**TOWN OF PORTOLA VALLEY
ARCHITECTURAL AND SITE CONTROL COMMISSION (ASCC)
Monday, October 13, 2014
Special Field Meeting (time and place as listed herein)
7:30 PM – Regular ASCC Meeting
Historic Schoolhouse
765 Portola Road, Portola Valley, CA 94028**

TO: ASCC
FROM: Karen Kristiansson, Deputy Town Planner
Carol Borck, Assistant Planner
DATE: October 13, 2014
RE: Agenda for October 13, 2014 ASCC Meeting

RE: Architectural Review for Electrification of Entry Gate, File #: 36-2014, 33 Grove Drive, Lands of Jernick

RE: Preliminary Architectural Review for a New Residence, Detached Garage, Shed, and Pool, File #: 37-2014, 110 Shawnee Pass, Lands of Wookey

SCALE: 1:32 WEIGHT: SHEET 1 OF 1

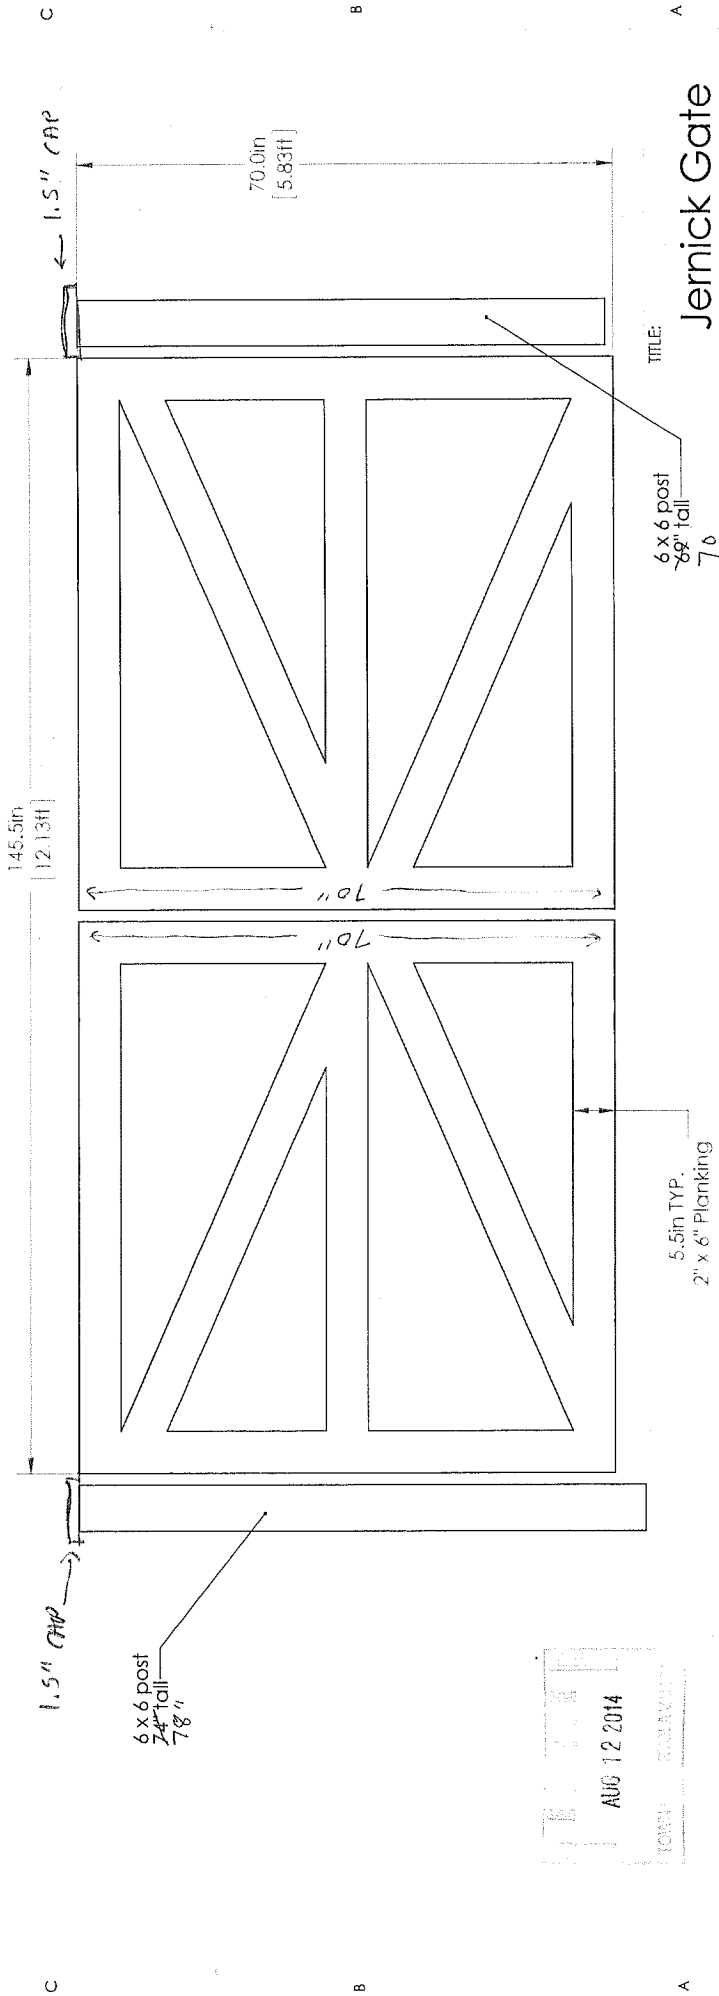
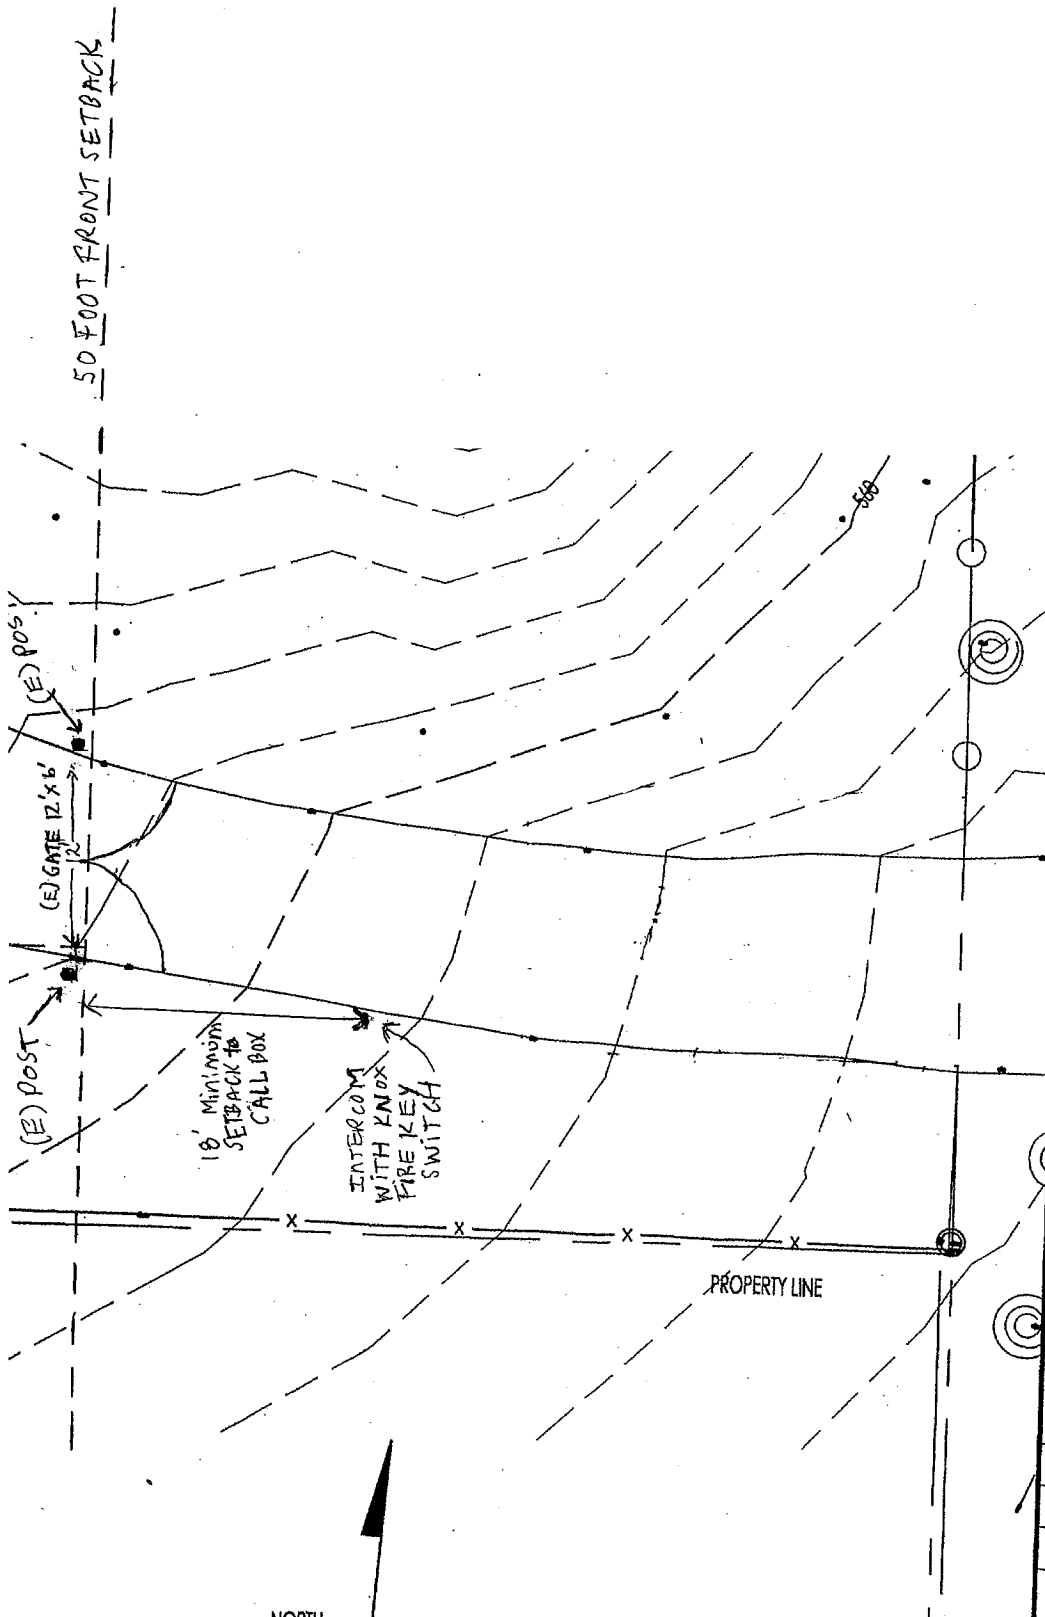
As shown on Sheet 1 of the enclosed plans, the existing gate is located more than 50' from the front property line. Therefore, the existing approximately six foot tall gate complies with Town standards. In addition, the gate also complies with the 50% opacity limit even though it is located outside of the front yard setback, as shown by the calculations on Sheet 1. The picture to the right shows the existing entryway gate.
